Felix Buechi *et al.*  
Appl. No.: 10/608,088

**Amendments to the Drawings:**

Appl.No. 10/608,088  
Reply to Office action of February 2, 2006  
Annotated Sheet Showing Changes

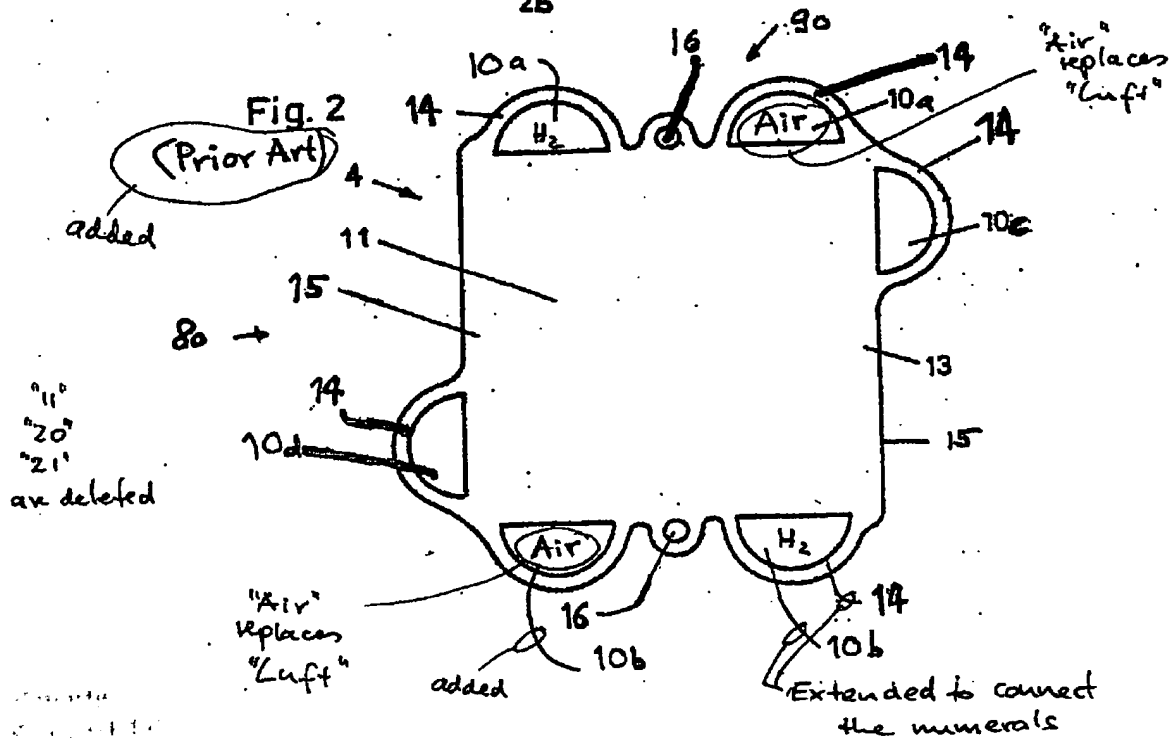
Figure 1 has been labeled as “Prior Art.” Further, in Figure 1, reference numerals 20 and 21 have been deleted.

The Examiner objects to the drawings under 37 C.F.R. §1.84(p)(5) for showing reference numerals not mentioned in the description, and under 37 C.F.R. §1.84(p)(4) for improperly using reference numerals for different items. Further, the Examiner requests labeling Figures 1 and 2 as Prior Art.

In Figure 1, reference numerals 20 and 21 have been deleted.

Further, Figures 1 and 2 have been labeled as "Prior Art."

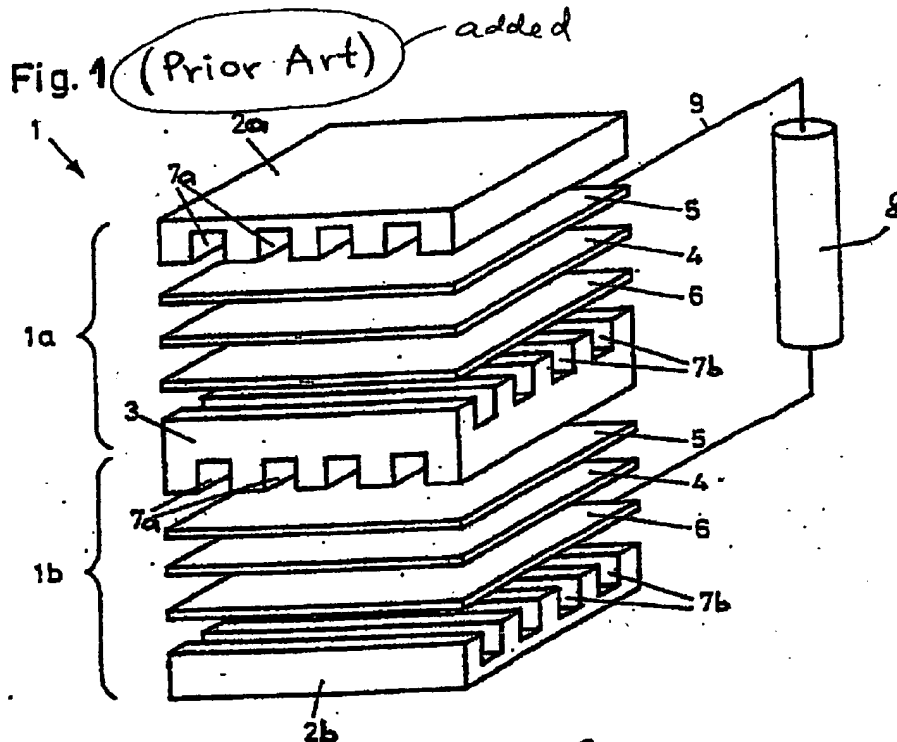
Figure 2 has been labeled as “Prior Art.” Further, reference numerals 11, 20 and 21 have been deleted. Lead lines and corresponding reference numerals have been clarified. German word “Luft” has been replaced by “Air.”

In Figure 2, reference numerals 11, 20 and 21 have been deleted. Lead lines and corresponding reference numerals have been clarified. German word "Luft" has been replaced by "Air."

Fig 3

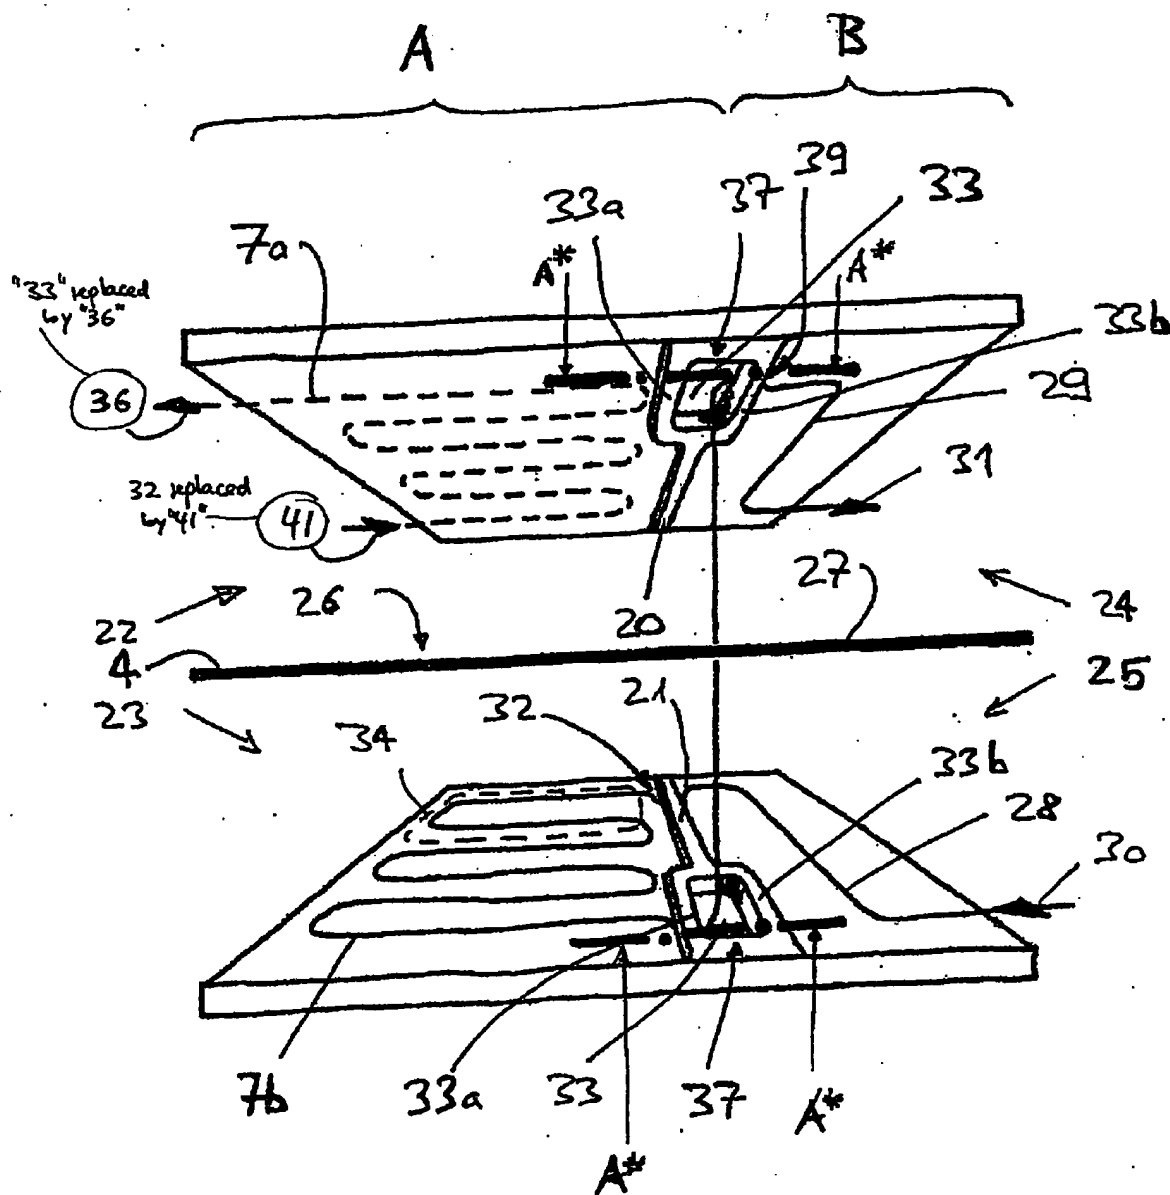
Figure 3 has been amended to label arrows as 36, 41 to avoid double use of numerals 32, 33.

In Figure 3, arrows at the input and output of channel 7a have been labeled as 36, 41 to avoid double use of numerals 32, 33.
